**Group of Experts for the revision of the IMO/ILO/UNECE
Guidelines for Packing of Cargo Transport Units**

Updates on the 1st draft of the Code of Practice (COP)

**Comments (Slovakia) submitted on the Code of Practice for
packing of Cargo Transport Units (CTU Code)**

Load distribution diagram of 40-foot container (Tare – 4000 kg, Gross mass – 30480 kg)

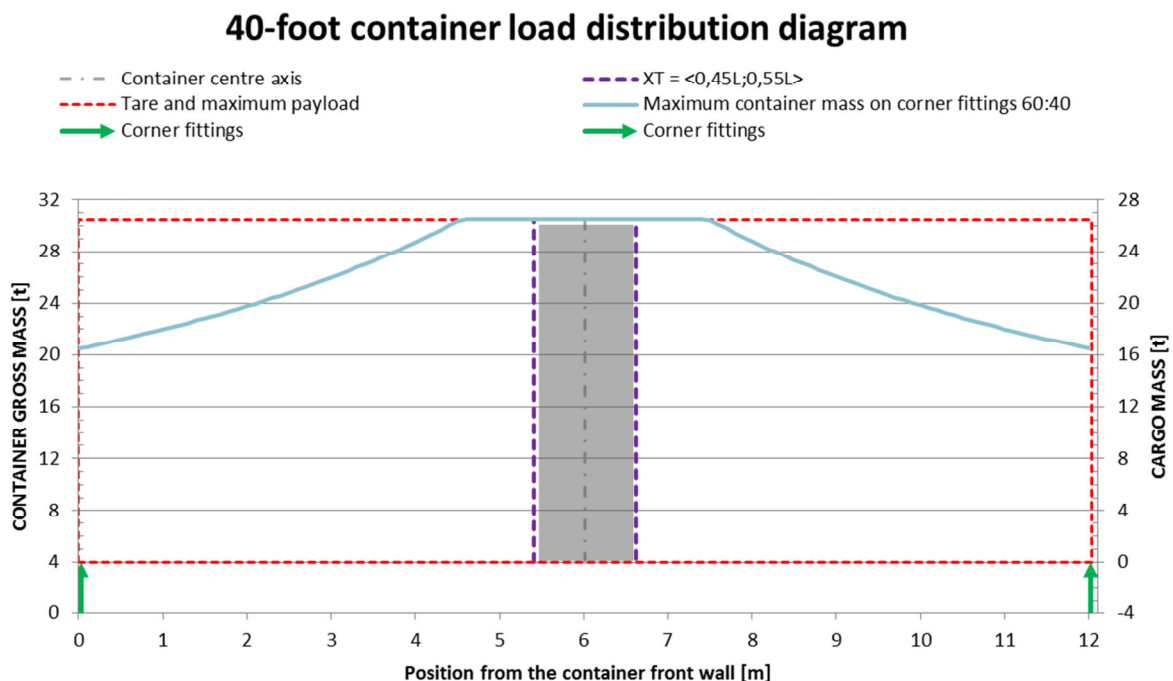
As it is not clear in current CTU guidelines nor in ISO 3874 the position of center of gravity in CTU longitudinal axis we suggest to clearly define that the center of gravity shall be within the boundaries of 0,45 L to 0,55 L (L - loading length). This limitation is very important for the operators how to place containers on vehicles or railway wagons not to overload axles.

The load shall be distributed in a way not exceeding 60% of mass in a container half according to the standard ISO 3874. This gives the eccentricity of the cargo centre of gravity 5% of loading length (L). Within the application of the rule container load distribution diagram can be constructed as example below.

Load distribution diagram of 40-foot maritime container loaded on two-axle Lgs container wagon and container chassis

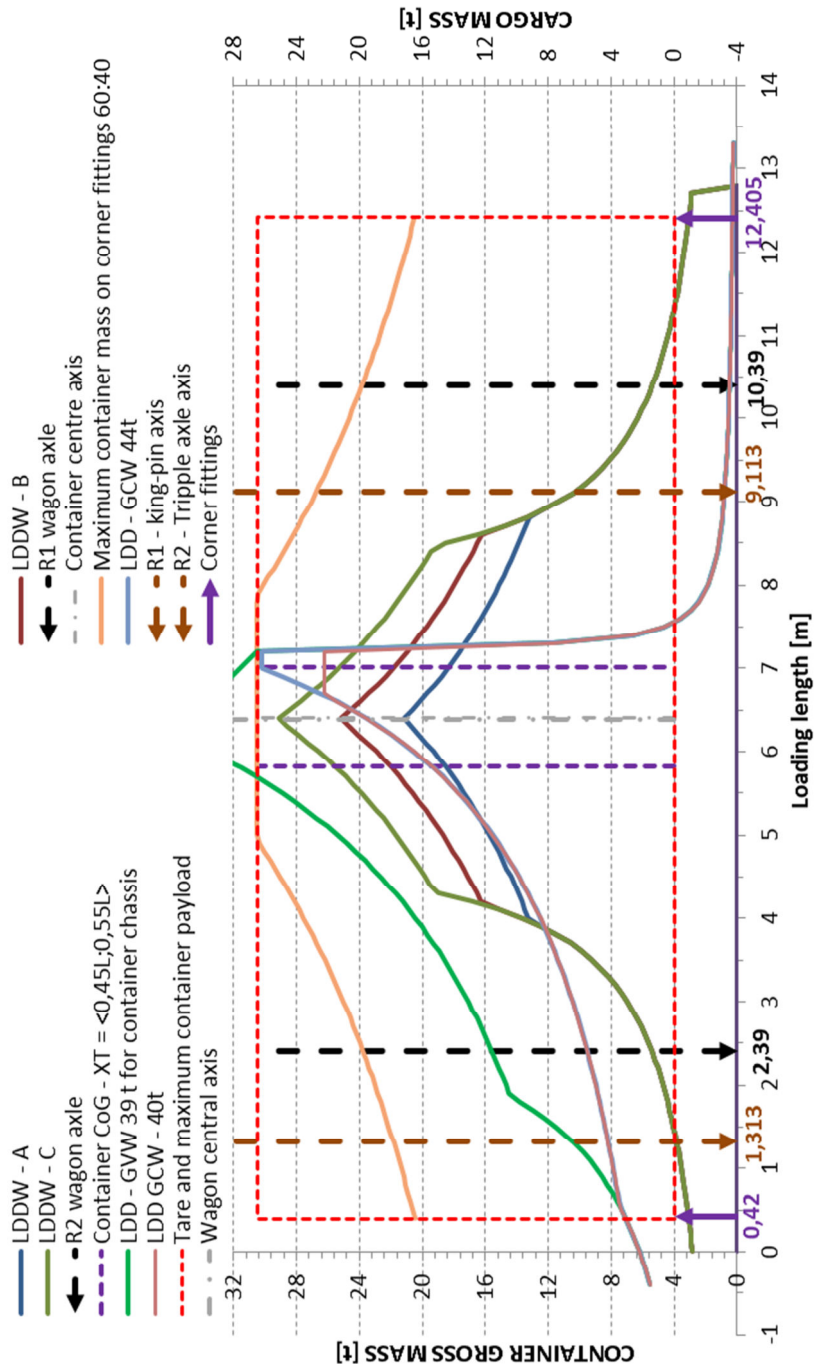
Load distribution diagram of vehicle mentioned in 11.10 is not enough to correctly stow the load in longitudinal axis for road, rail and sea transport. Therefore we suggest Intermodal load distribution diagram, where load distribution diagram of container, container wagon and container chassis are combined as an example below.

According to our opinion the packer will not construct load distribution diagram, therefore this information is not necessary in the code in 11.10.4. Different curves are used for railway wagon.

Formula for the calculation of total centre of gravity of loaded cargo (in longitudinal or also in transverse and vertical axis) and example of such calculation would be helpful for packers.
